**SERVICE BULLETIN**

**APPLICABILITY:** 2015-16MY Outback  
 2014-16MY Forester  
 Models with Power Rear Gate (PRG)

**NUMBER:** 07-103-15

**SUBJECT:** PRG Rod Servicing / One-Time Use Part Information

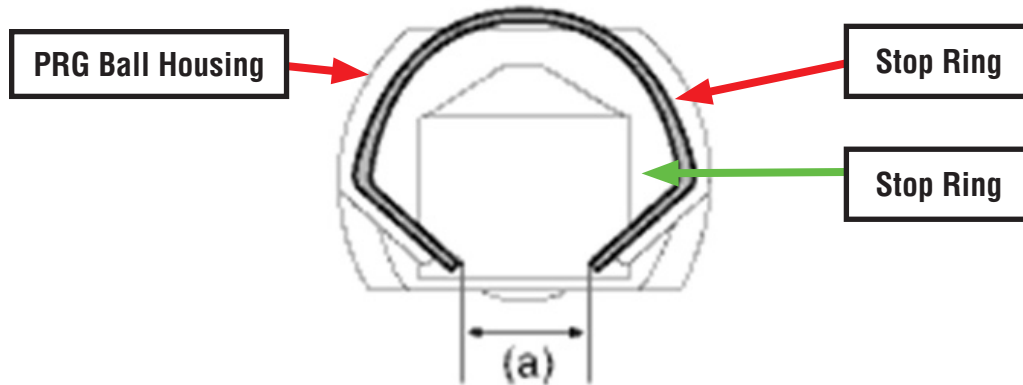
**IMPORTANT:** When replacing the stop ring, **CAREFULLY** and gradually, apply force to install it onto the ball (pivot) housing. **DO NOT** use any excessive force which could deform the part. In the illustration below, the specification for dimension “a” is 6.4 – 7.2mm (.250” - .280”). If dimension “a” exceeds 7.2mm (.280”), the stop ring must be replaced. **NEVER** attempt to bend the clip back into specification.
